Re: **Initial Submission Review** – Porteos Infrastructure Site Plan Phase 7
Application Number: **DA-1903-16**
Case Number: **2020-6005-00**

INFRASTRUCTURE CONTEXTUAL SITE PLAN NO.7 AT PORTEOS

PORTEOS - PHASE 7
INFRASTRUCTURE SITE PLAN
EASEMENT EXHIBIT

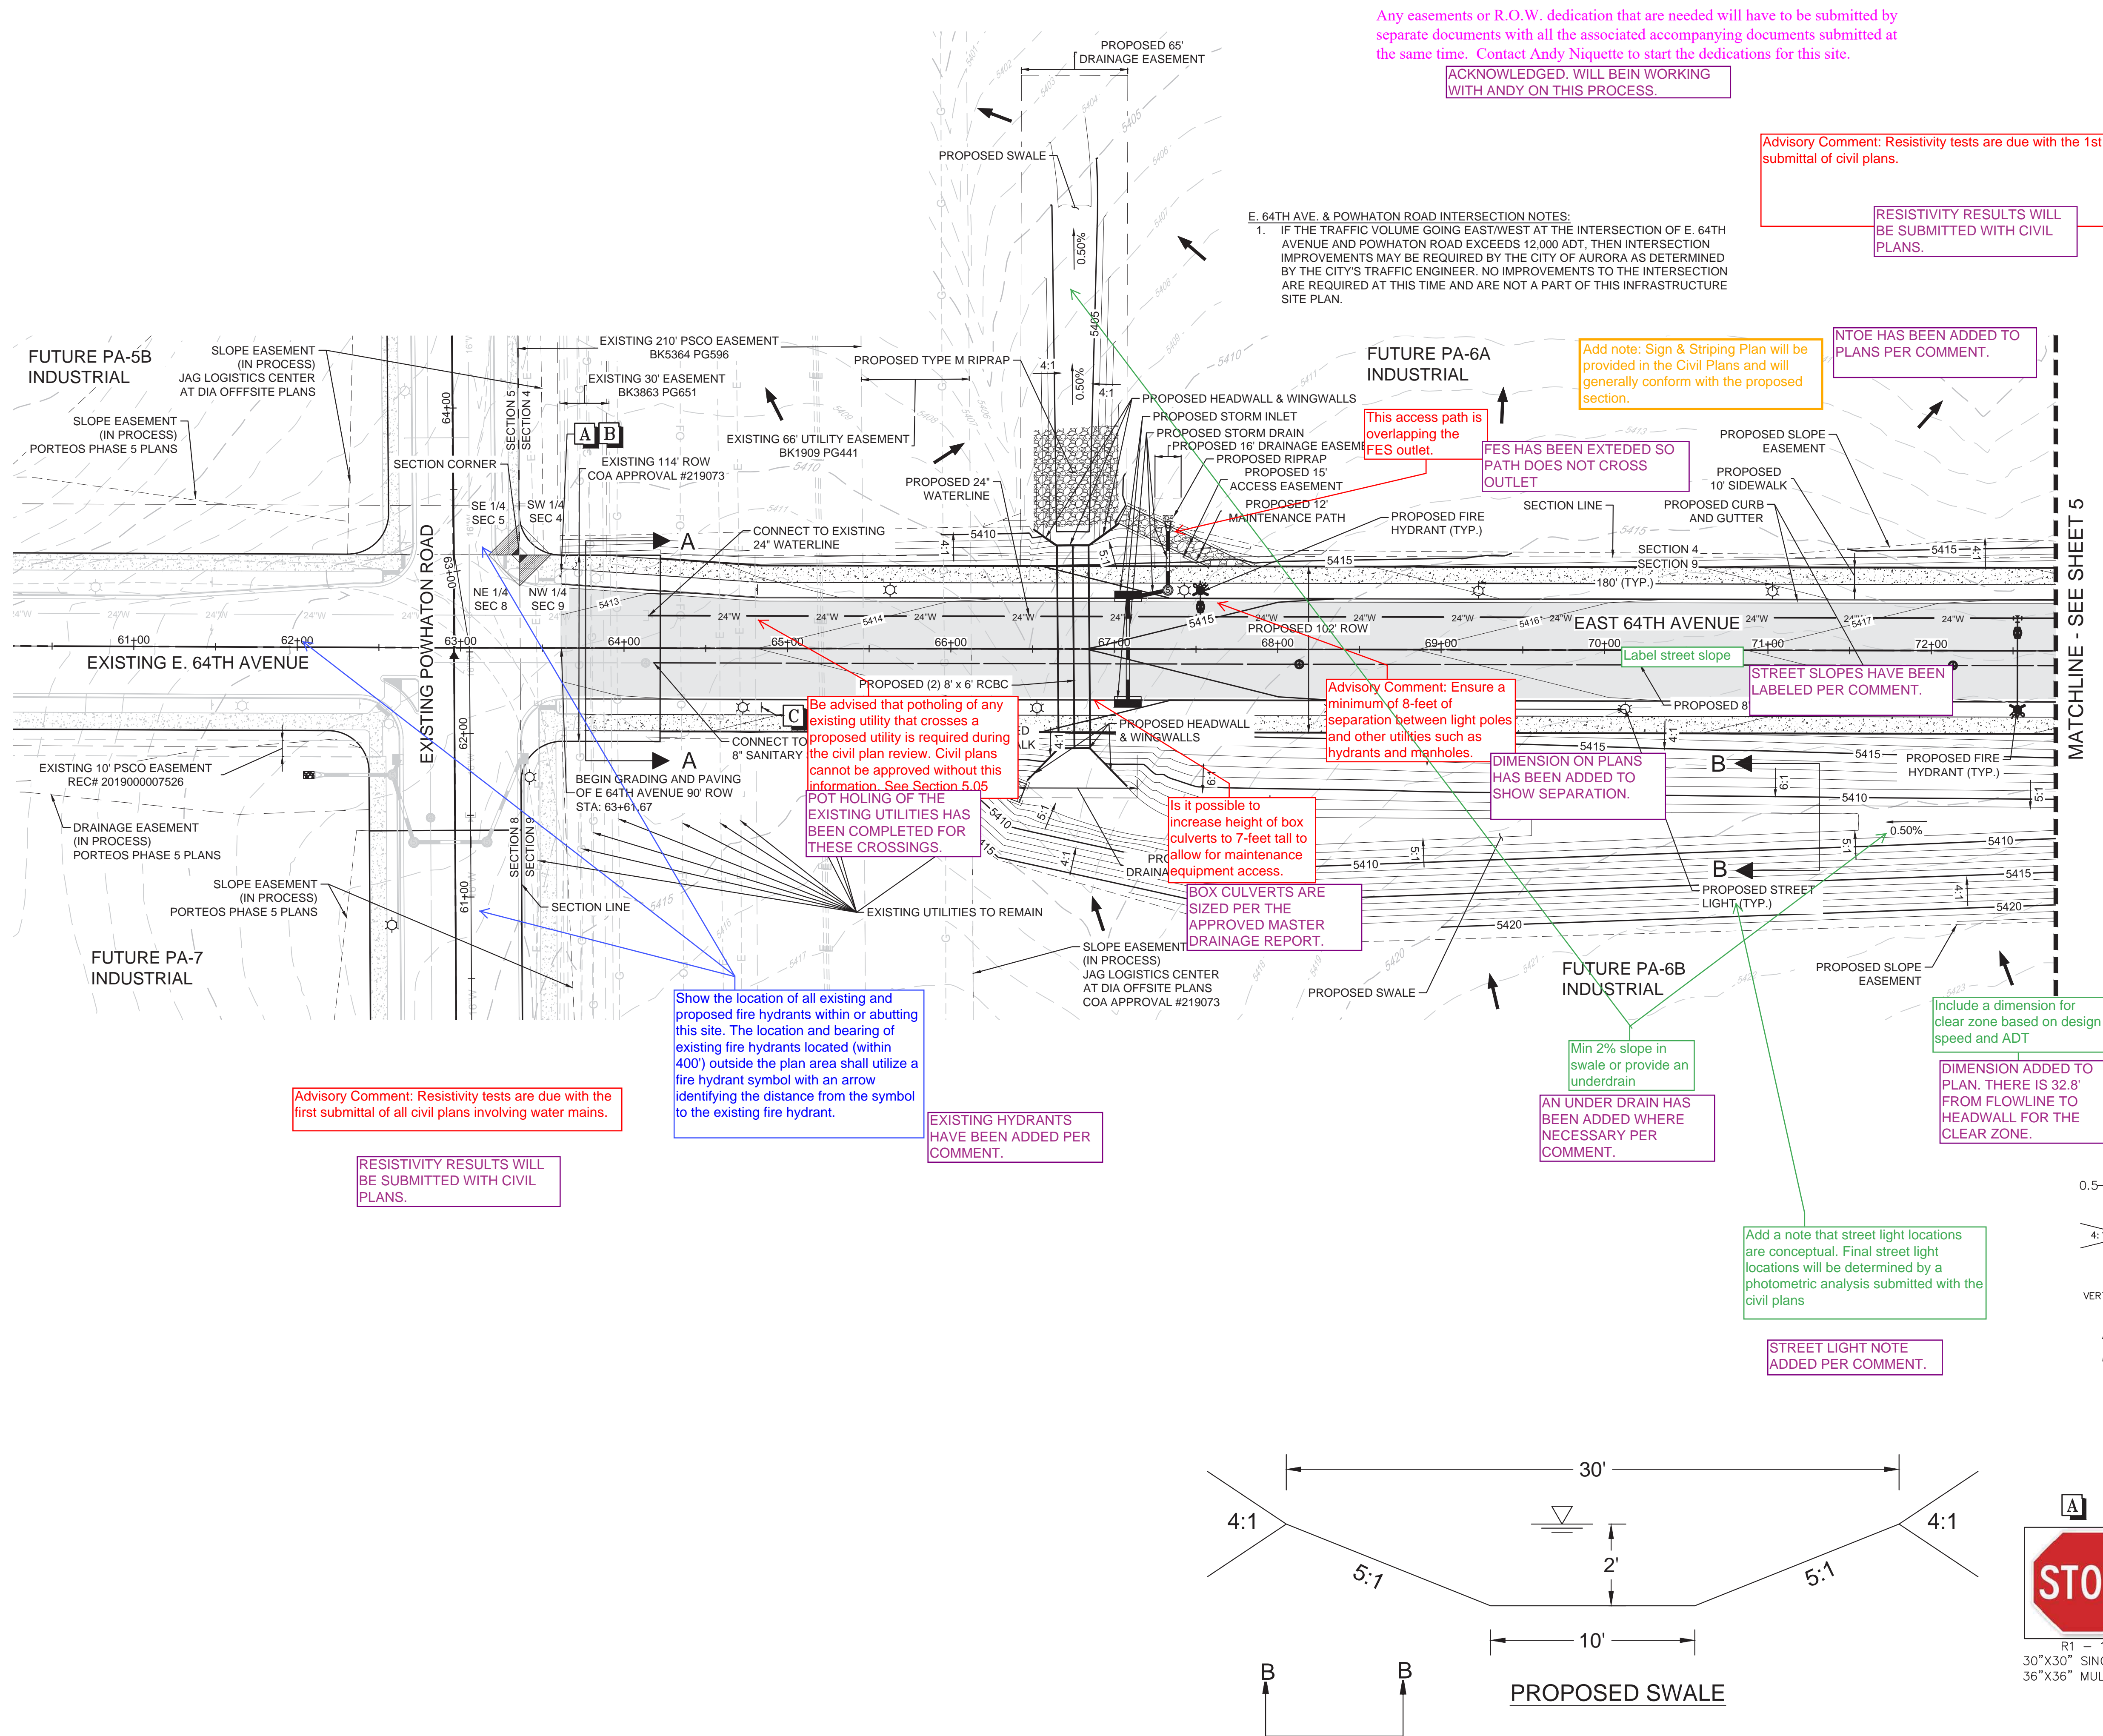
Any easements or R.O.W. dedication that are needed will have to be submitted by separate documents with all the associated accompanying documents submitted at the same time. Contact Andy Niquette to start the dedications for this site.

ACKNOWLEDGED, WILL BEIN WORKING WITH ANDY ON THIS PROCESS.

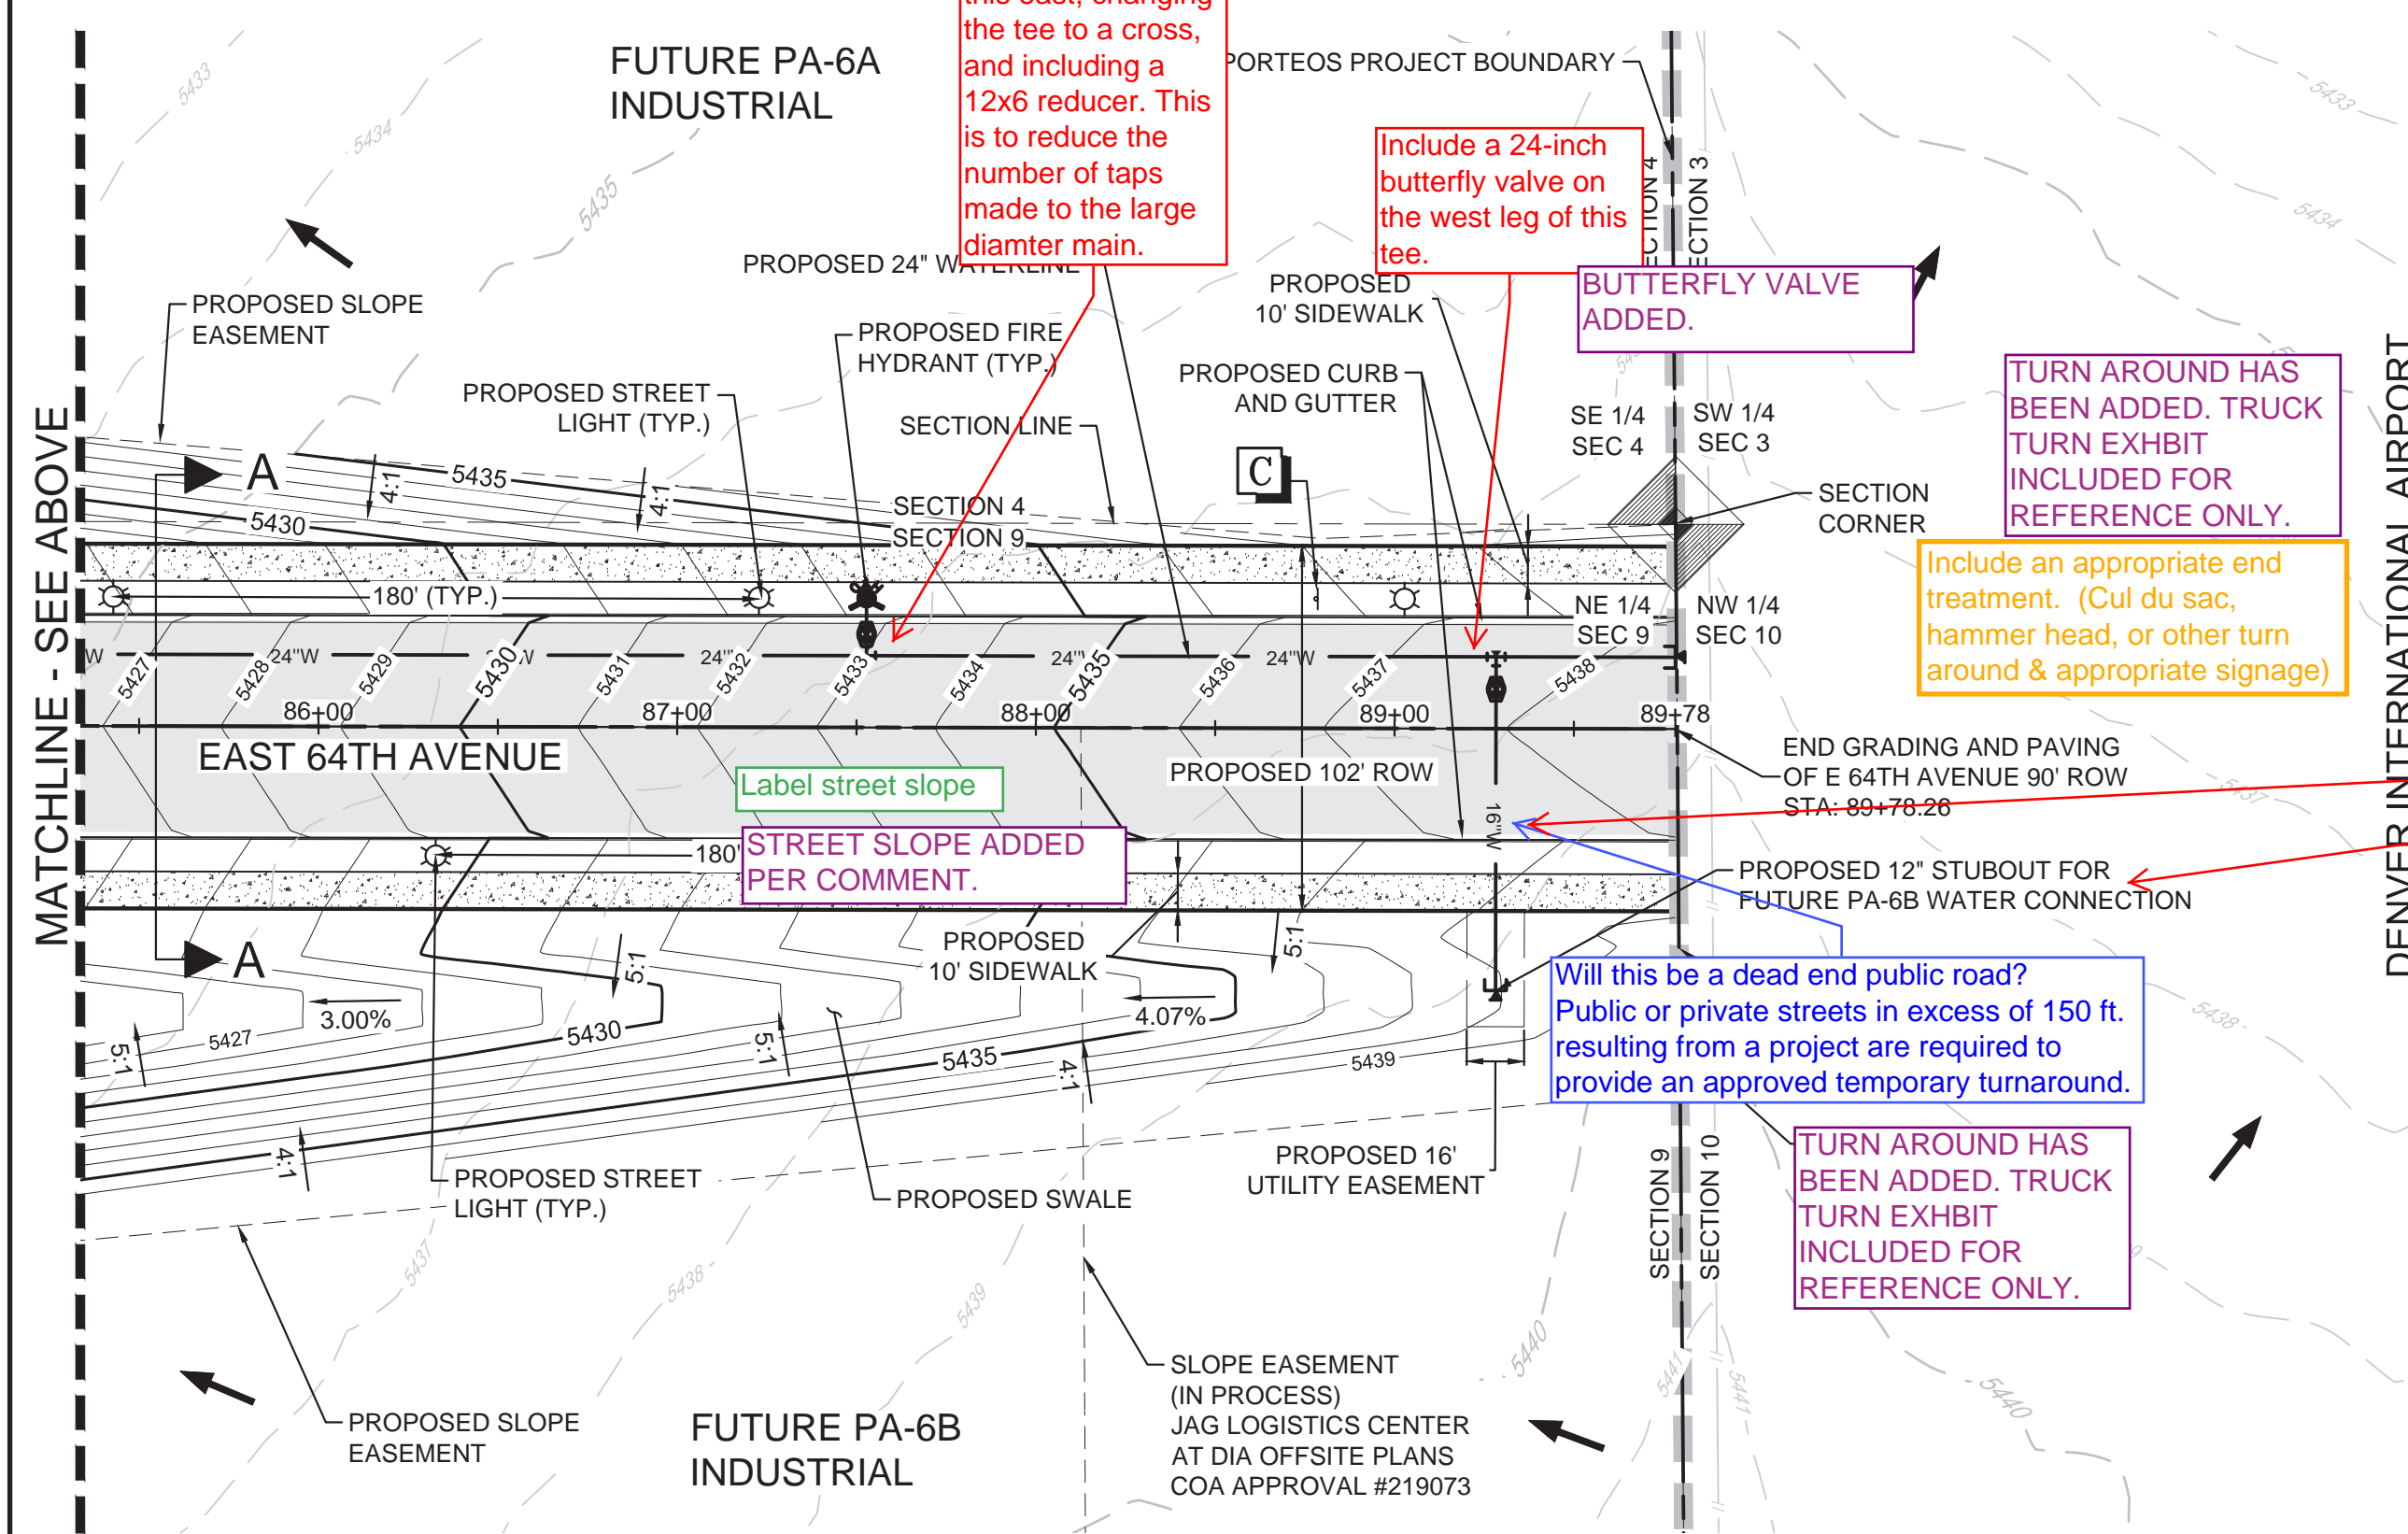
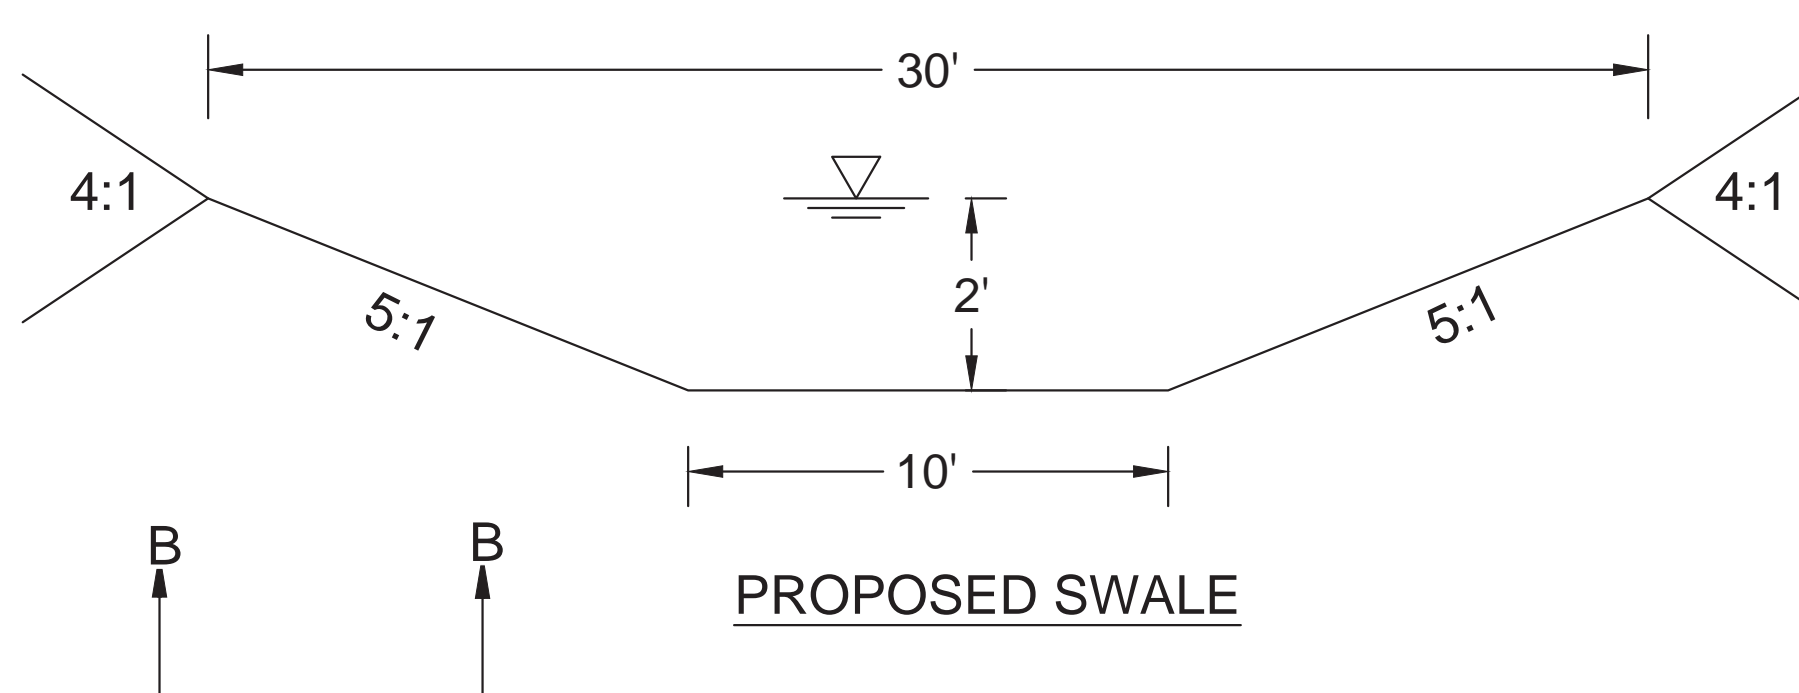
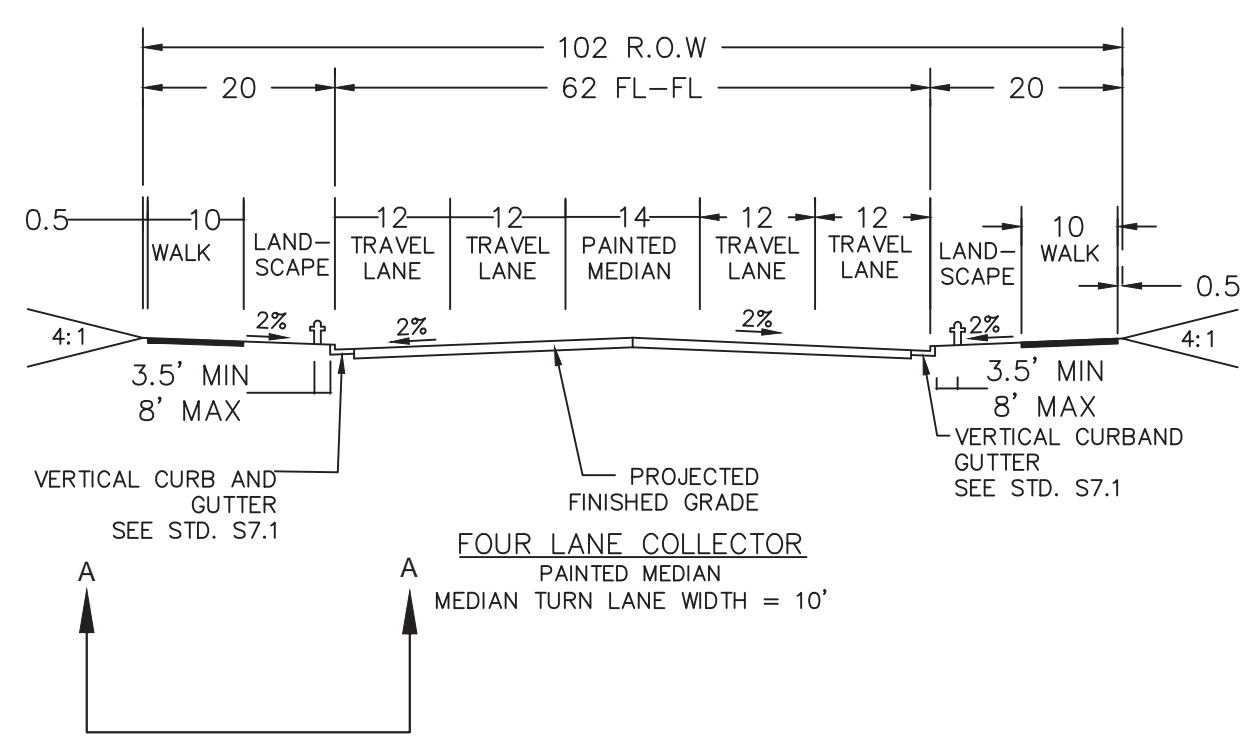
Include an appropriate end treatment. (Cul du sac, hammer head, or other turn around & appropriate signage)

Will this be a dead end public road?
Public or private streets in excess of 150 ft.
resulting from a project are required to
provide an approved temporary turnaround.

TURN AROUND HAS BEEN ADDED. TRUCK TURN EXHIBIT INCLUDED FOR REFERENCE ONLY.

TURN AROUND HAS BEEN ADDED. TRUCK TURN EXHIBIT INCLUDED FOR REFERENCE ONLY.

3 TREE PLANTING DETAIL

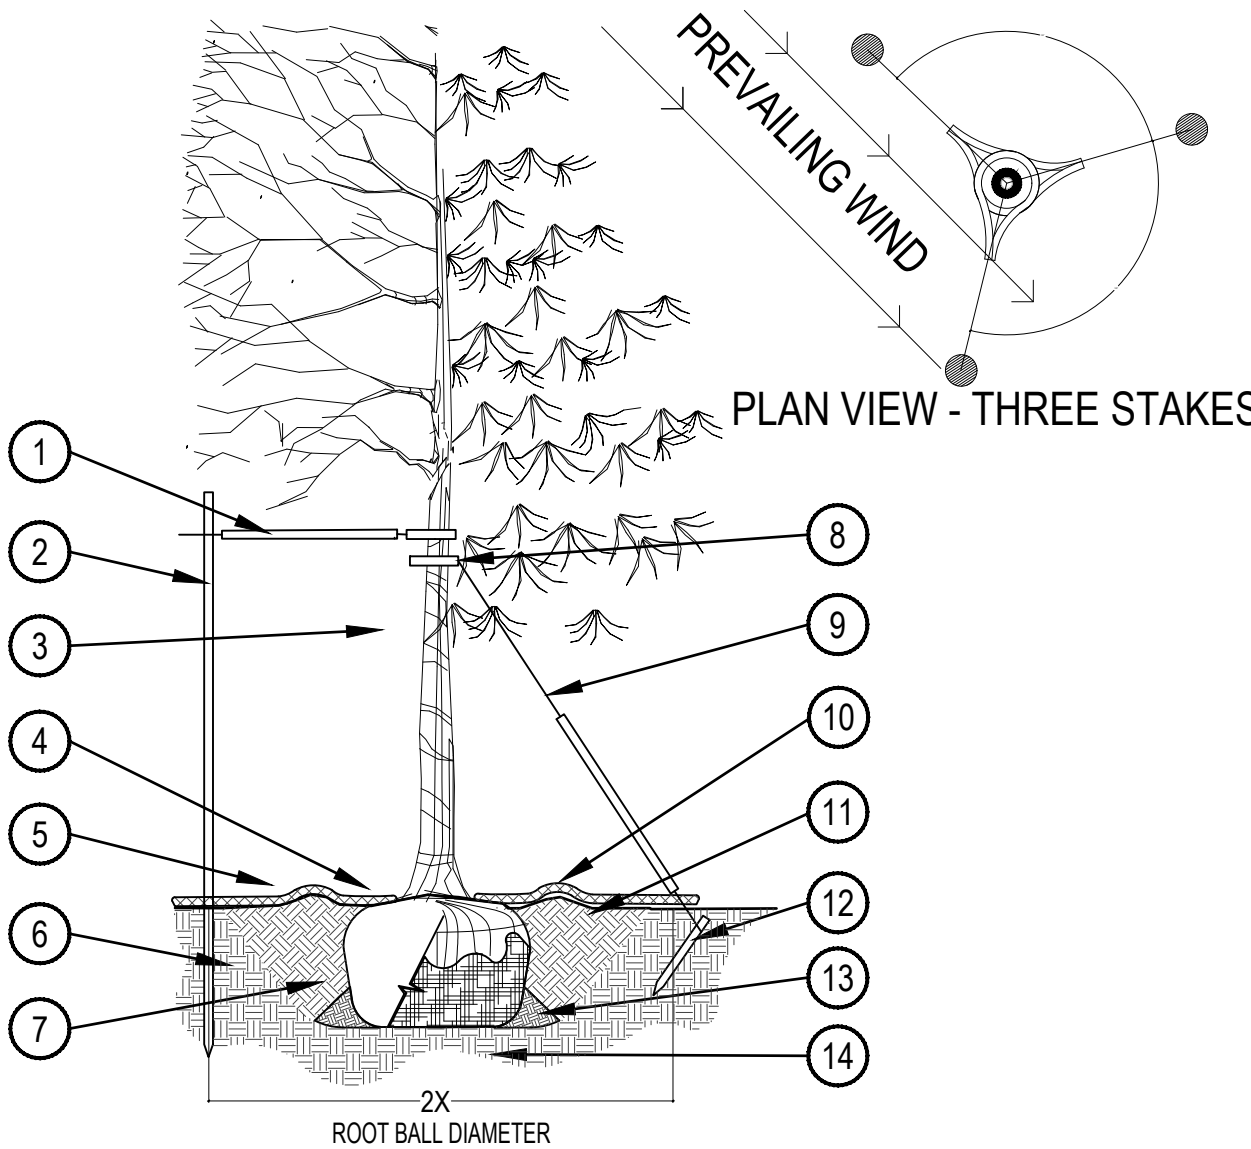
Add "Not for Construction" to all landscape sheets.
Response: Not for Construction has been added to all landscape sheets.
